# *RF distribution/diagnostic update*

# RF Distribution – Neglecting Vacuum Support Platform

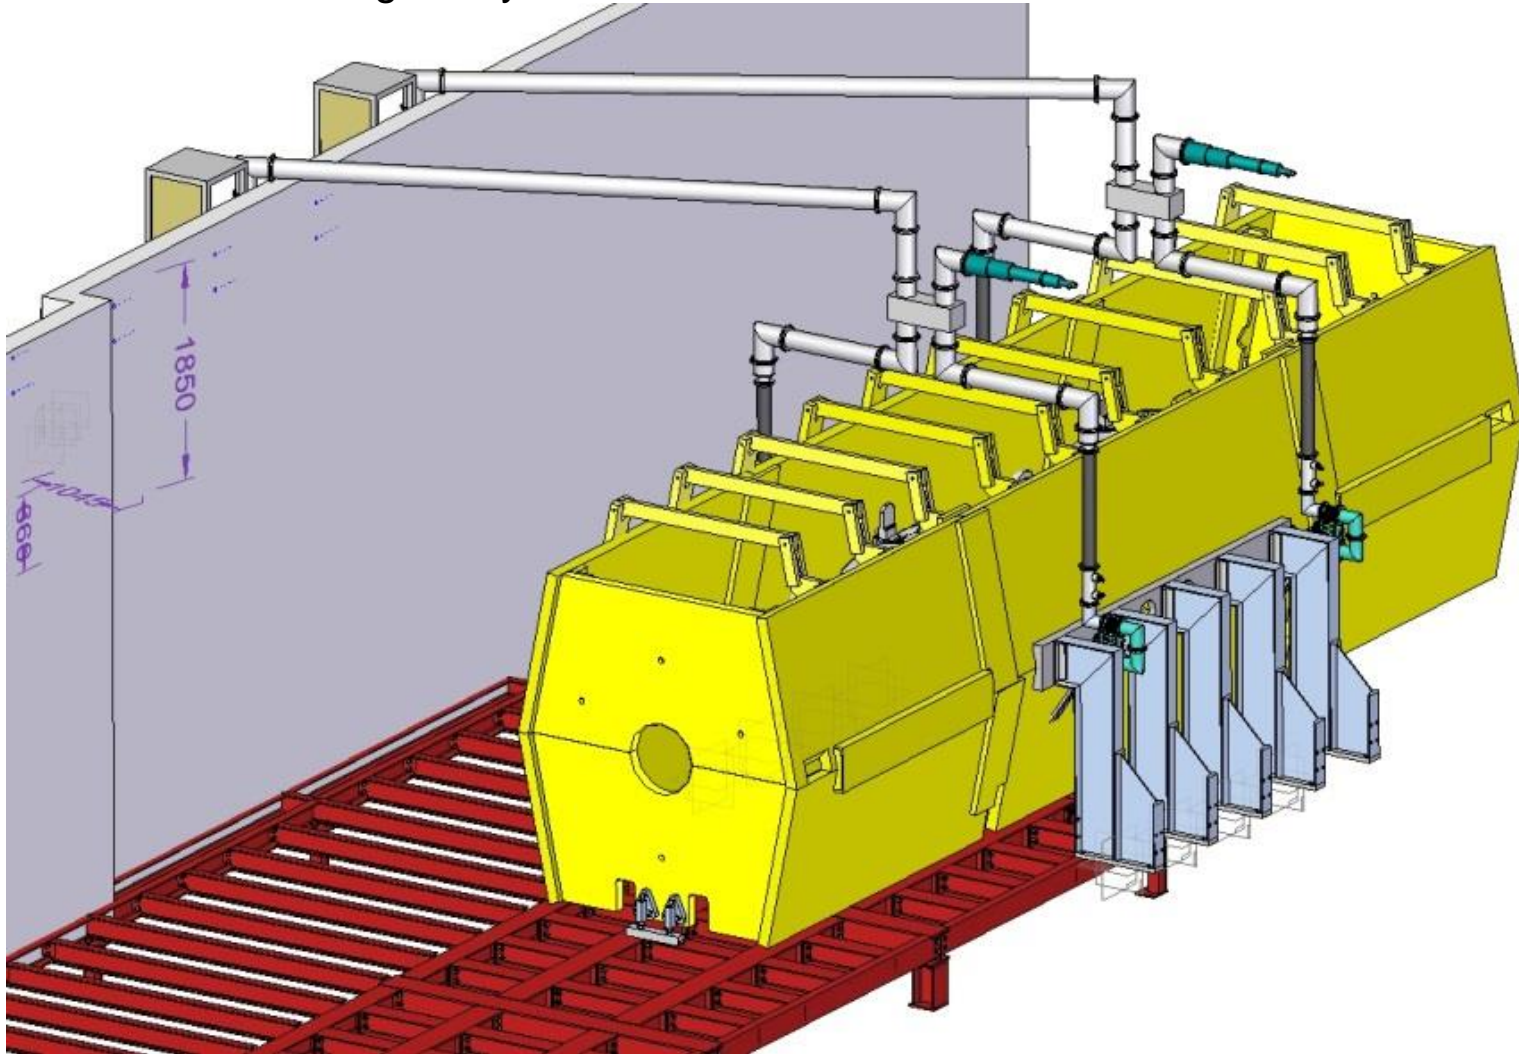
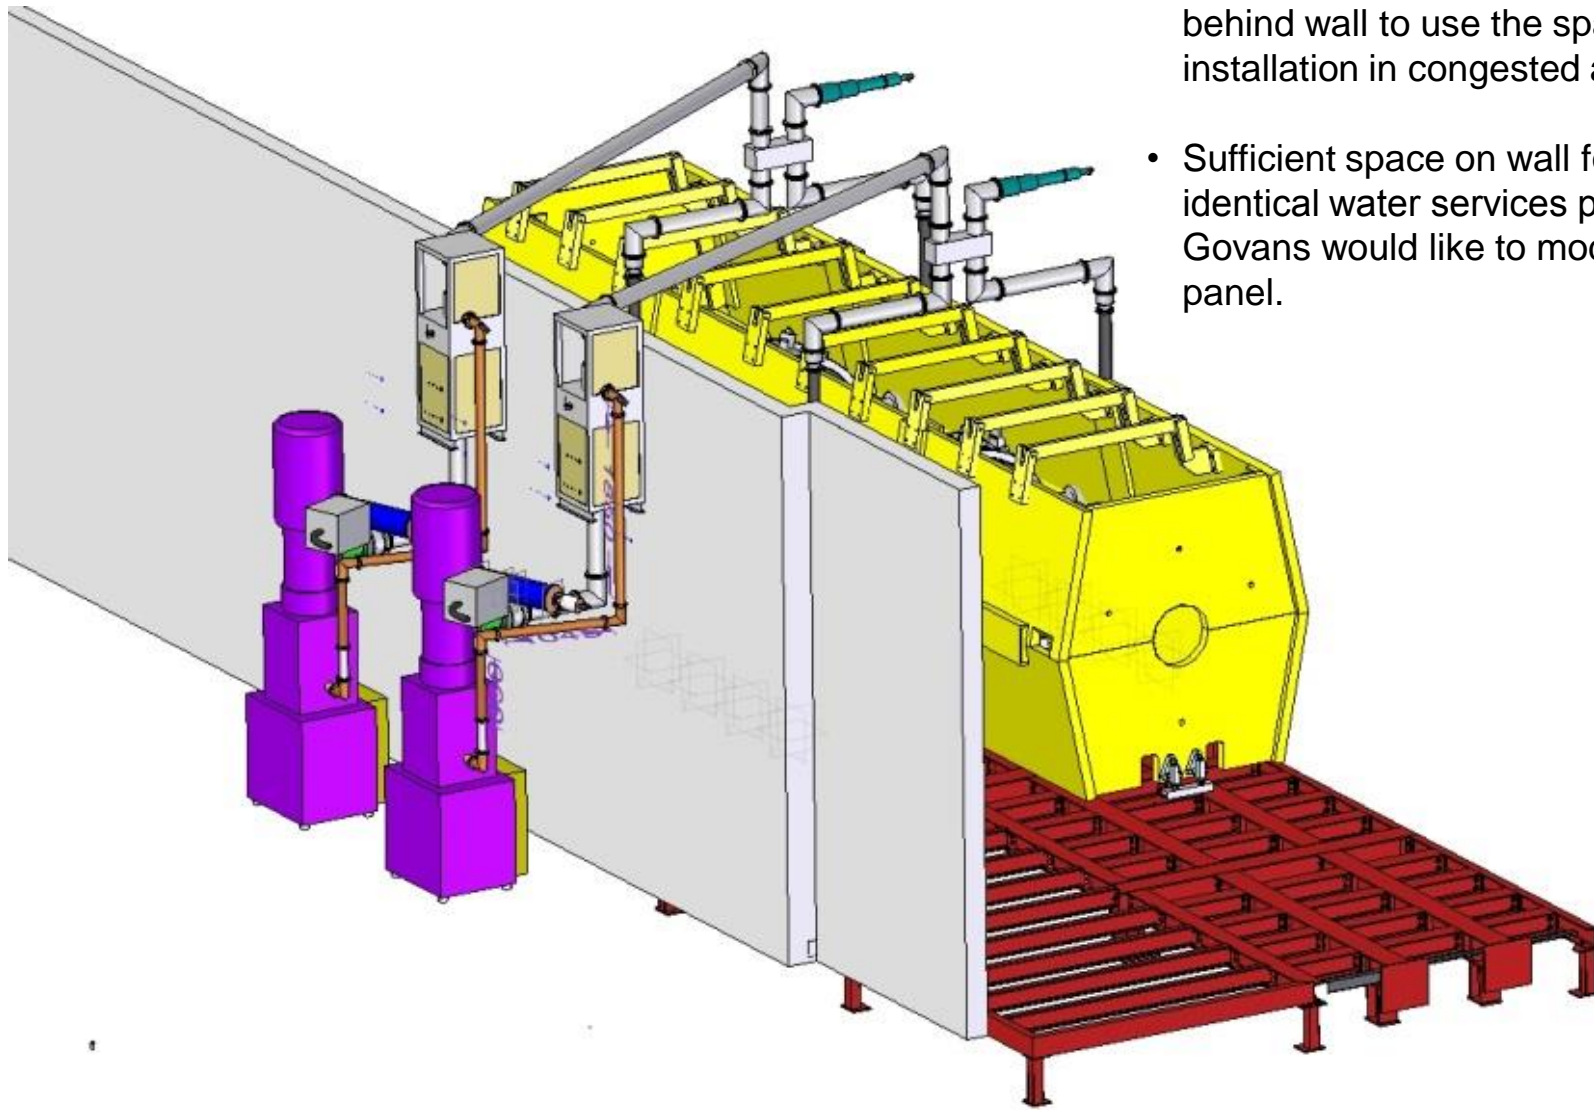
- MTA advised not to use ‘T’ splitters, suggested hybrid splitter was a better solution as it isolated the cavity couplers from each other.
- Propose to have 1off dummy load on the hybrid splitter to each RF cavity.
- Crane hook height fully retracted does not clash with the coax over the wall.

# RF Distribution – With Vacuum Support Platform

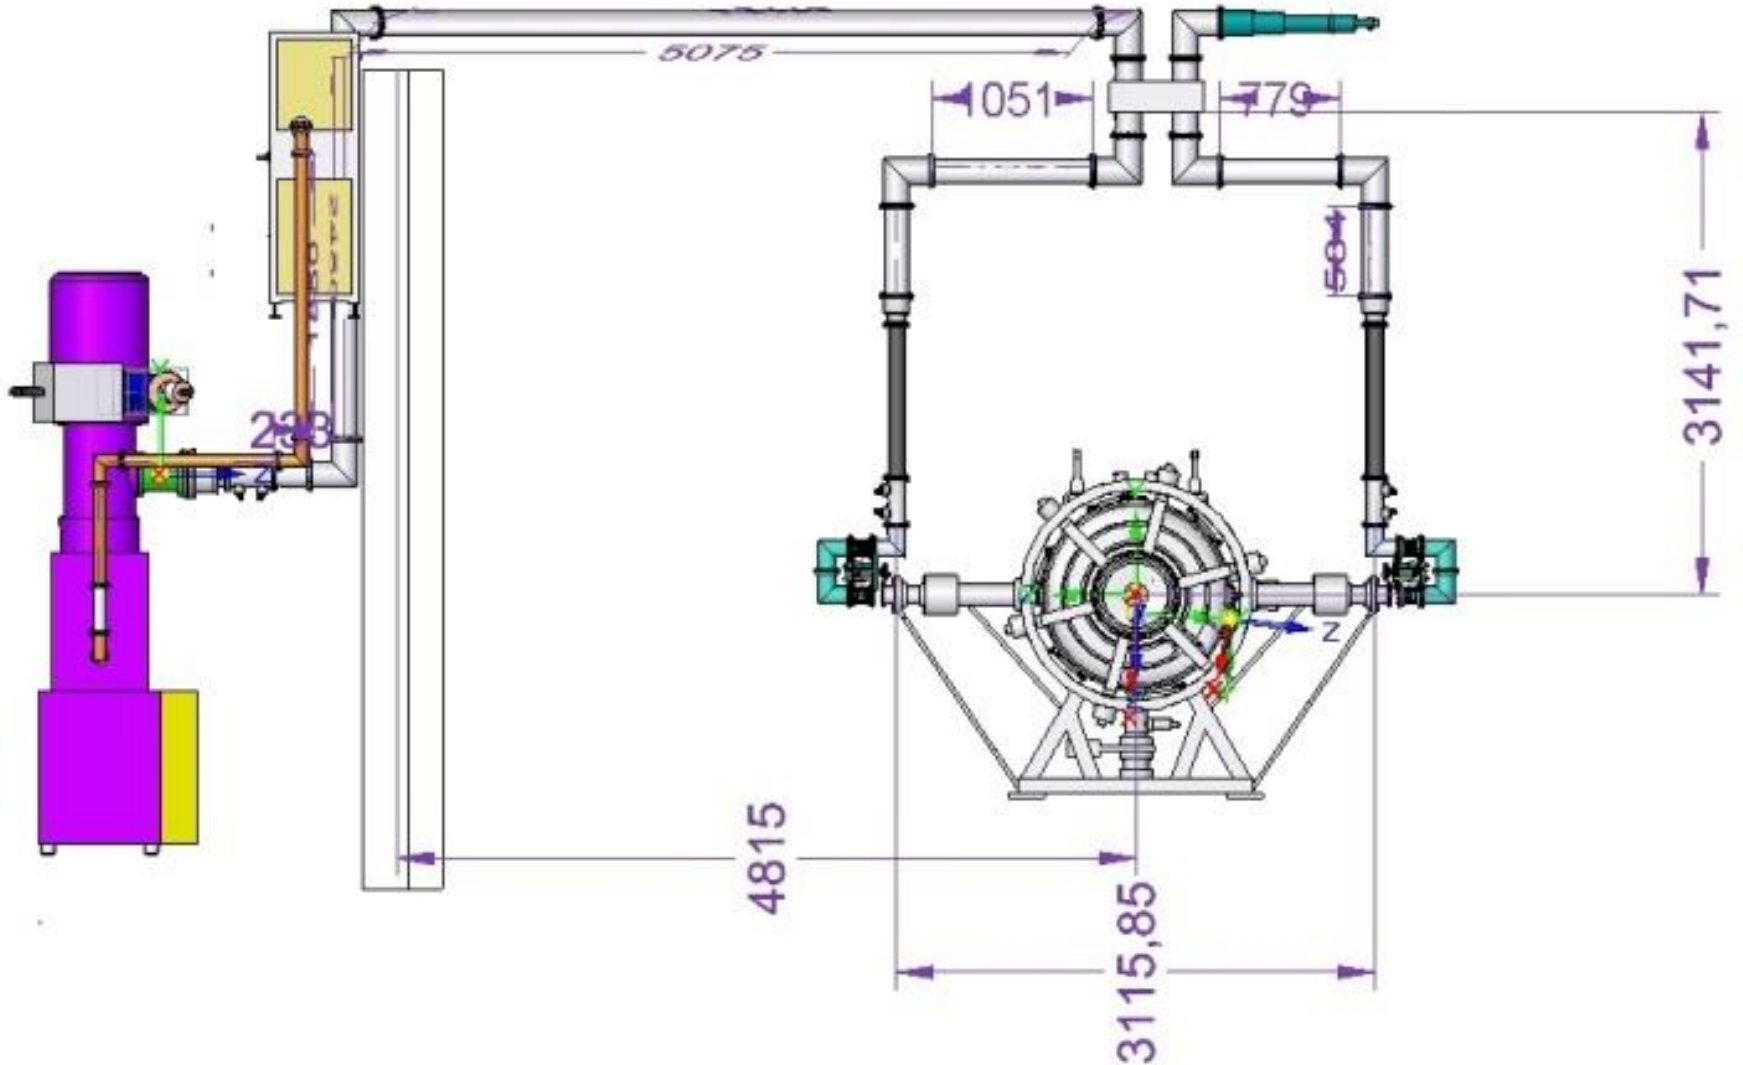
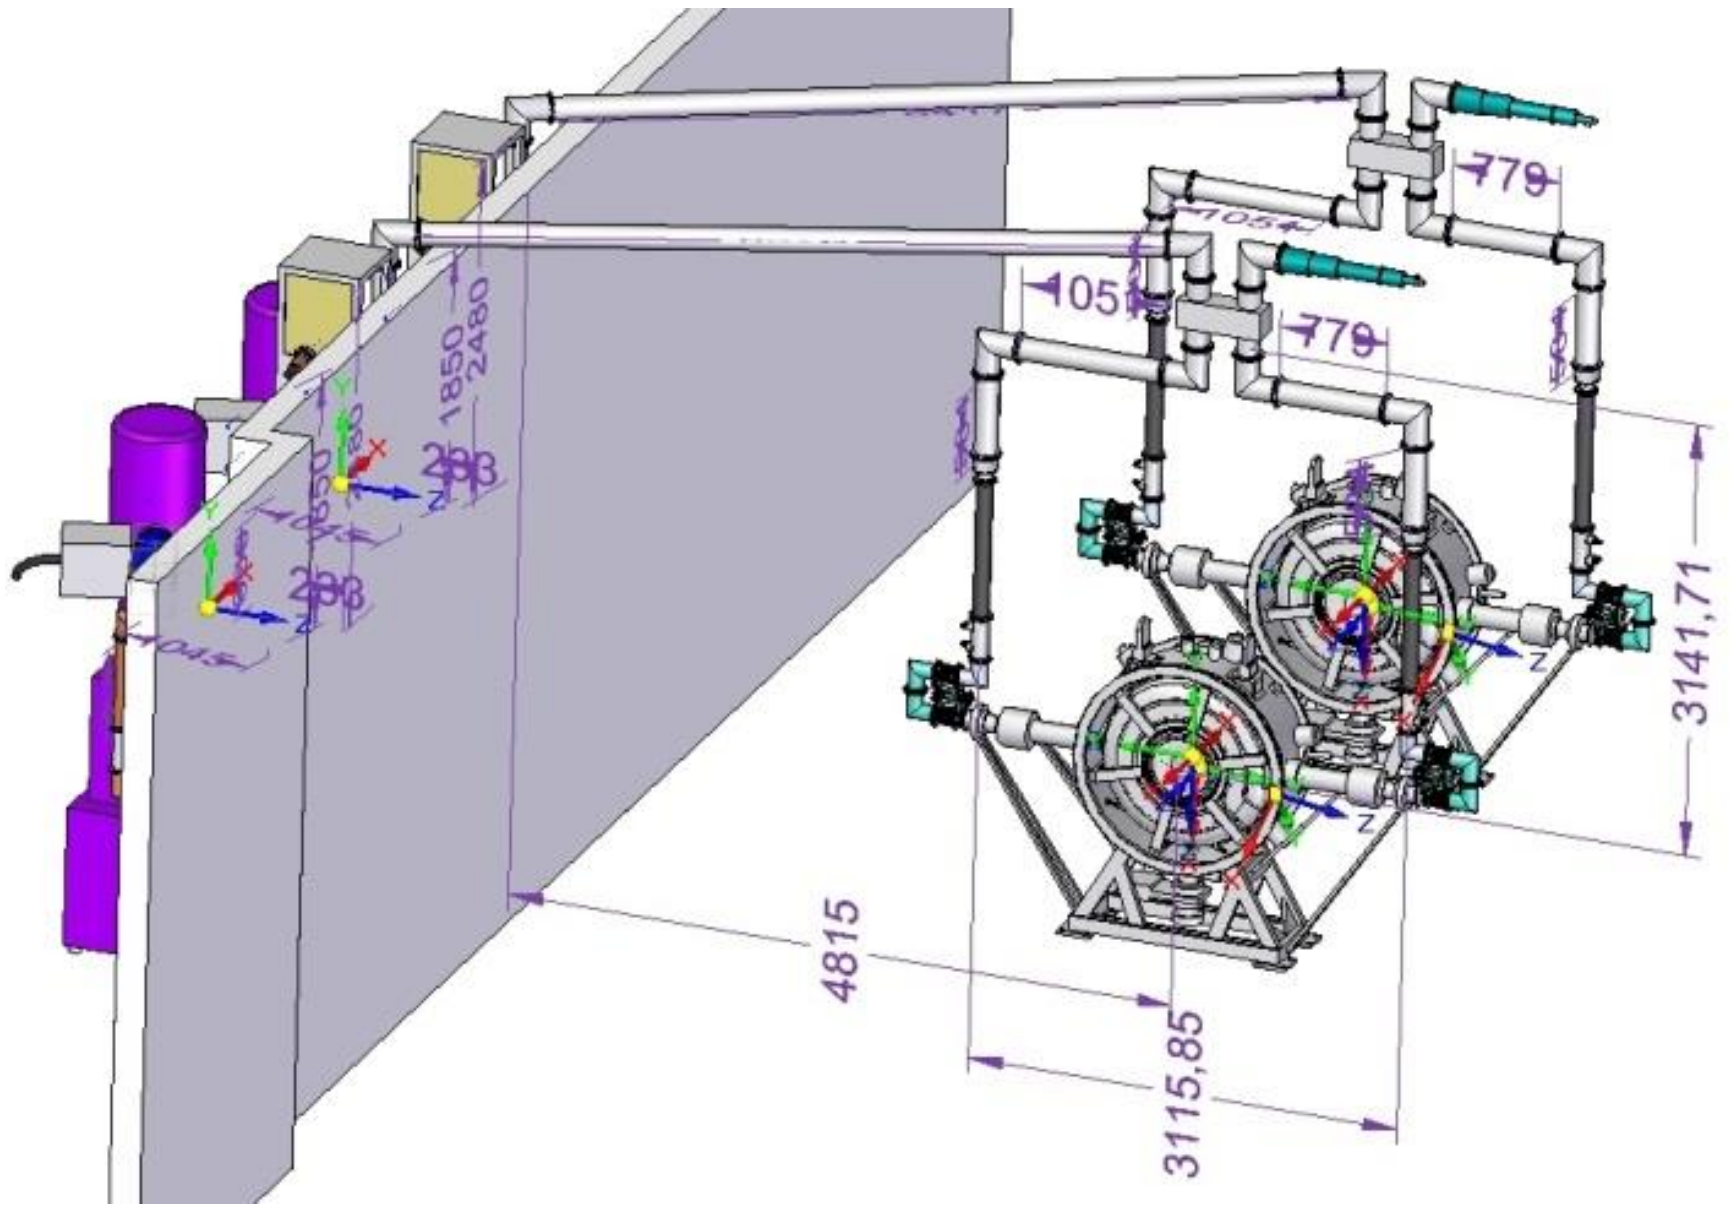
- Coax over the wall raised to avoid clash with vacuum support platform
- Crane hook height fully retracted may cause a potential clash with the coax.....need to check
- Option for crane operation maybe to skate equipment under high level coax line
- Services to dummy loads not yet been considered.....need to speak to Jason

- RF components routed over SS vacuum support platform “Dog Kennel”
- “Dog Kennel” can provide shielding for RF components
- Raised the height of the coax line over the wall from 242mm to 410mm, crane height appear to allow adequate margin
- Hybrids splitters can move upstream & downstream & lowered to avoid any potential clashes, achieved by setting correct rotation angles on coax lines
- Suggest mounting coax supports off PRY steel work & “Dog Kennel” .....need to liaise with Jason & Steve Plate

# RF Distribution – Hybrids Behind North Wall

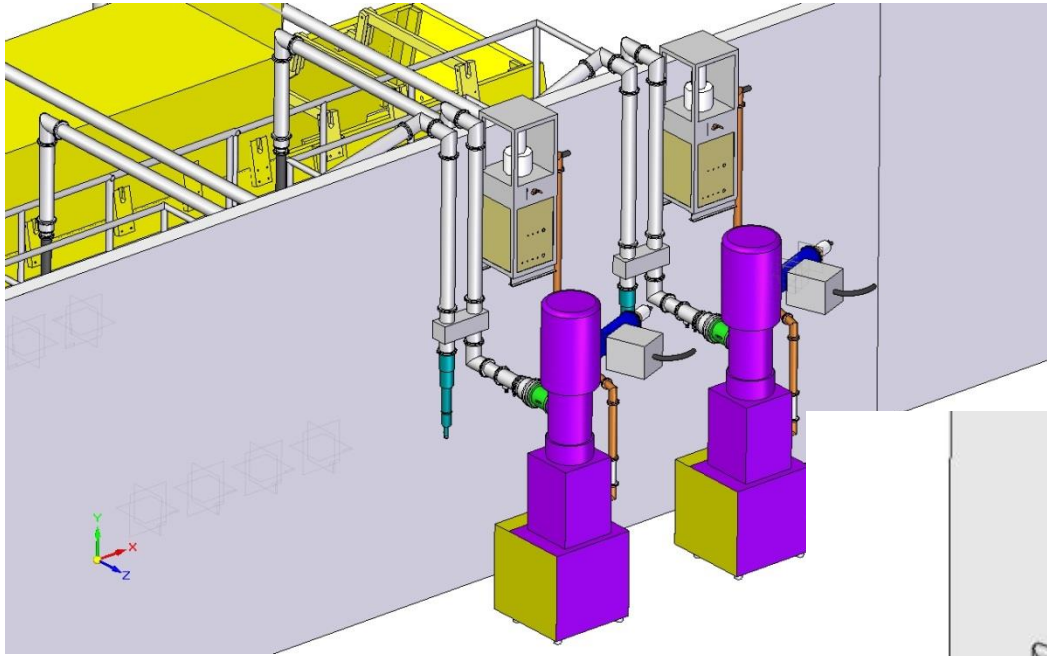
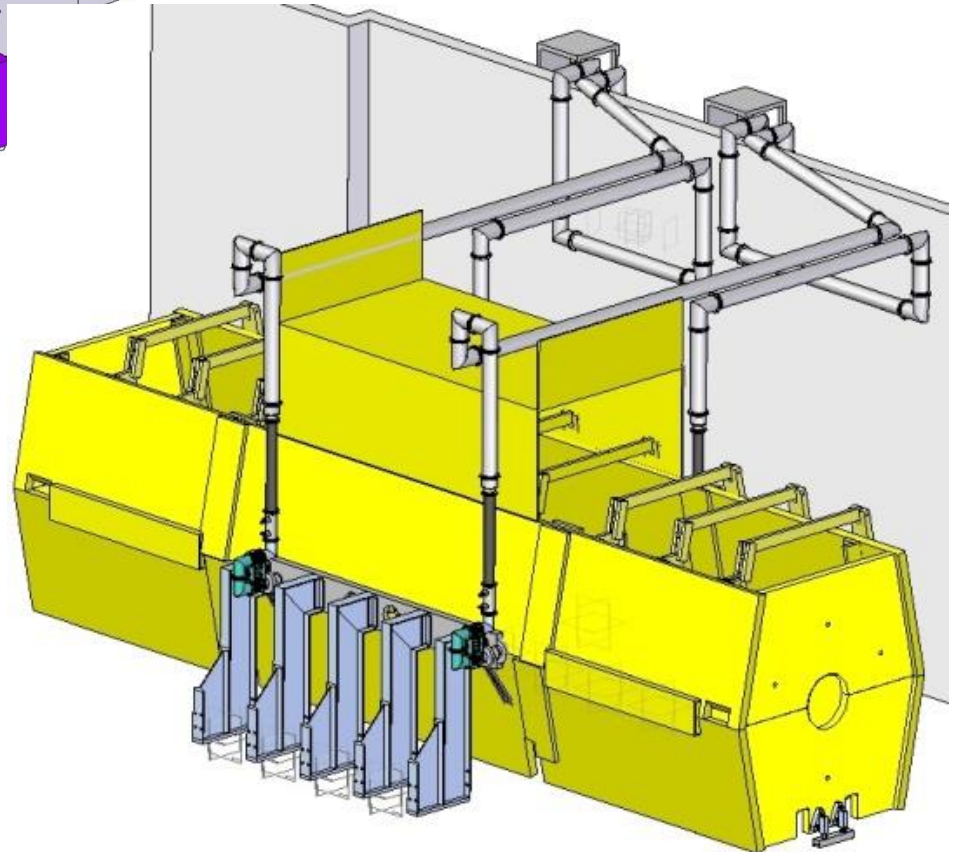
- Hybrids and elbows no longer above cooling channel reducing stray field effects.....if stray field is a problem!!!
- Coax can run lower once over the wall
- Services to reject loads might be easier

- More coax required to match lengths to each side of the cavity
- More elbows required.....need same number of elbows to each side of the cavity to equalise the losses to both sides
- Generally more losses due to increased lengths of runs
- Larger SF6 volume required
